# Superfund Record of Decision:

Cross Brothers Pail  
(Pembroke), IL

<b>REPORT DOCUMENTATION PAGE</b>		1. REPORT NO. EPA/ROD/R05-89/106	2.	3. Recipient's Accession No.
4. Title and Subtitle SUPERFUND RECORD OF DECISION Cross Brothers Pail (Pembroke), IL First Remedial Action - Final			5. Report Date 09/28/89

FIGURE 9  
Localized PCB Soil  
Area

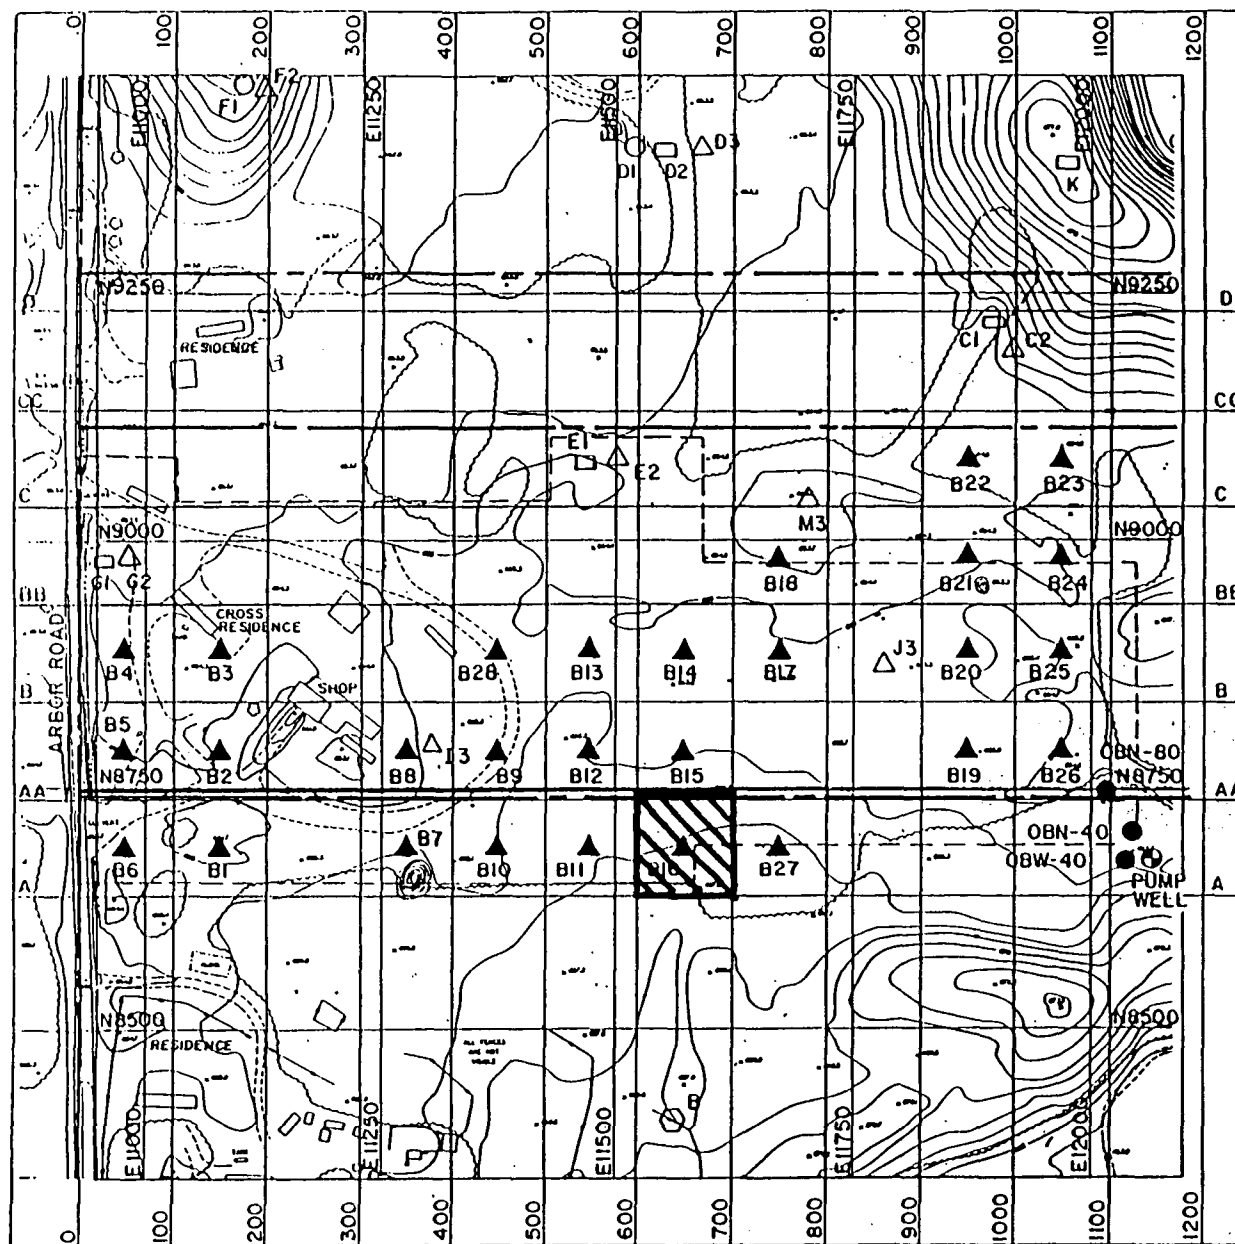
Comment 5: Inclusion of the PCB-contaminated soil option in the preferred alternative is based on only 1 soil sample. The uncertainty associated with the level of contamination and the volume of soil affected should be addressed as soon as possible.

Response: The Agencies' PCB-contaminated soil option explicitly states that the area identified be resampled prior to initiating excavation. The primary purpose of the resampling effort is to define the level of contamination and the volume of soil affected in that area.

FIGURE 10  
ALTERNATIVE 2 LAYOUT

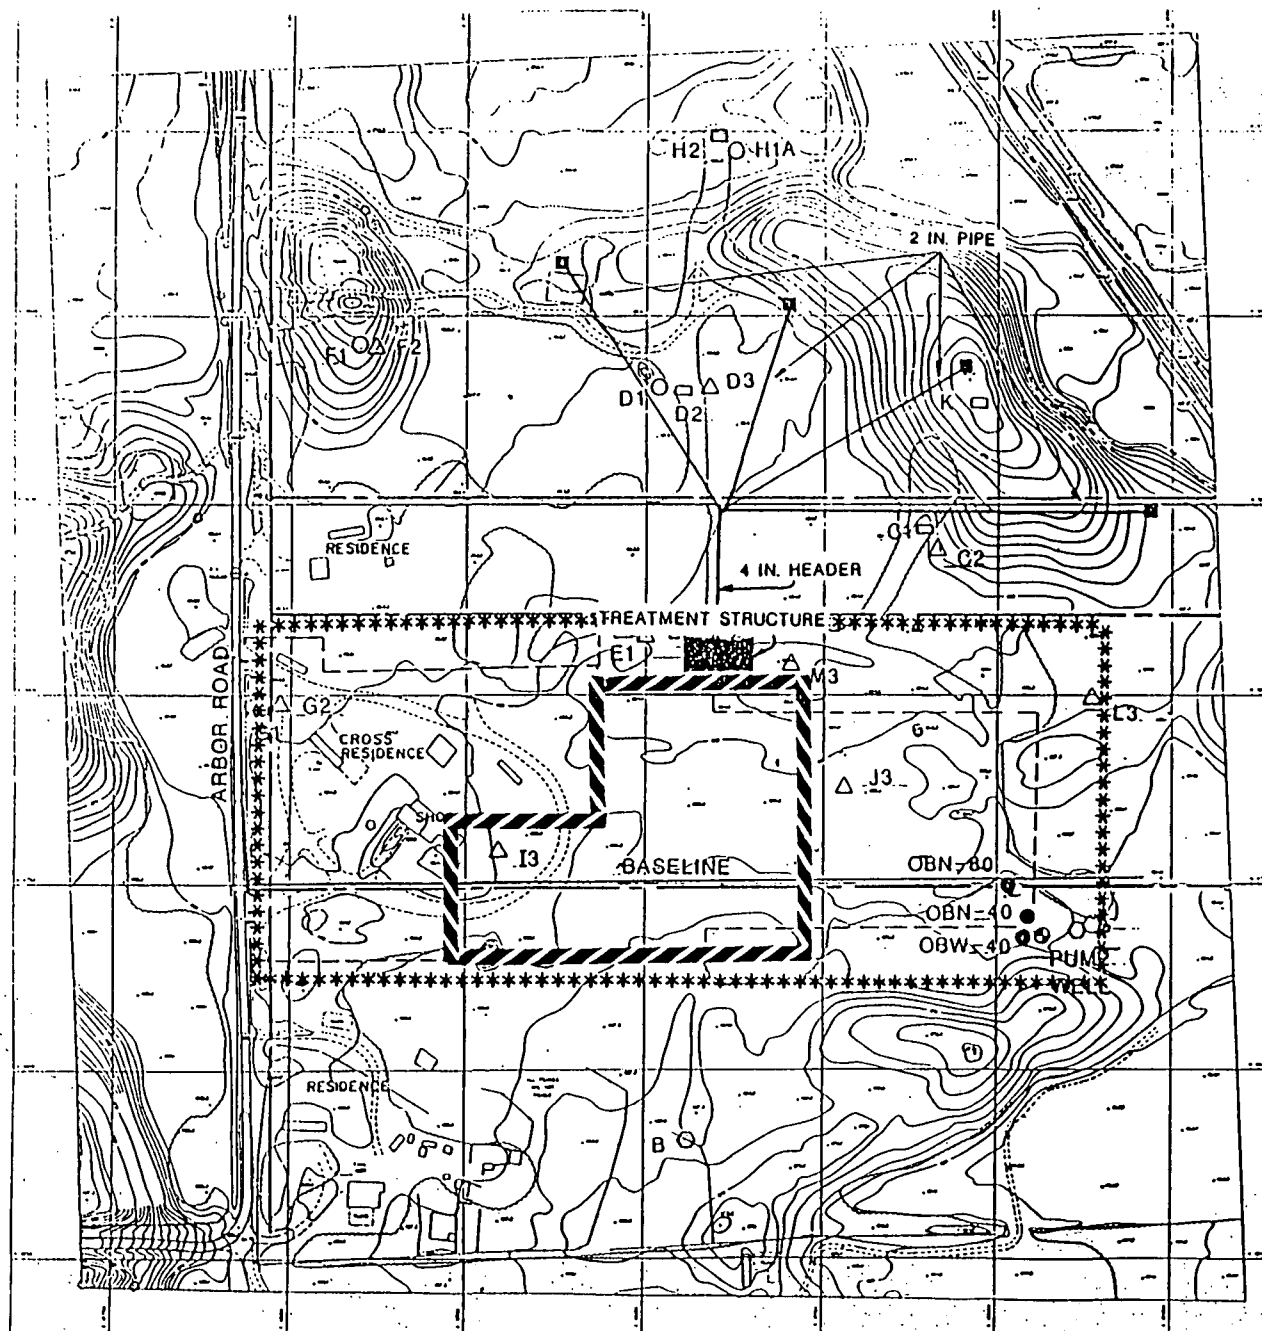
Comment 1: There appears to be a discrepancy between the measured groundwater flow direction and the modelled groundwater flow direction. This discrepancy appears to have resulted in placing the extraction wells too far to the east in the FS. Modelled groundwater flow and measured flow should be reconciled prior to final selection of extraction well locations.

Response: The Agencies agree with this comment. The FS was not, however, meant to be a design document. The FS presents merely a "conceptual picture" of the various alternatives considered by the Agencies. Actual extraction well locations will be determined during development of the Remedial Design.
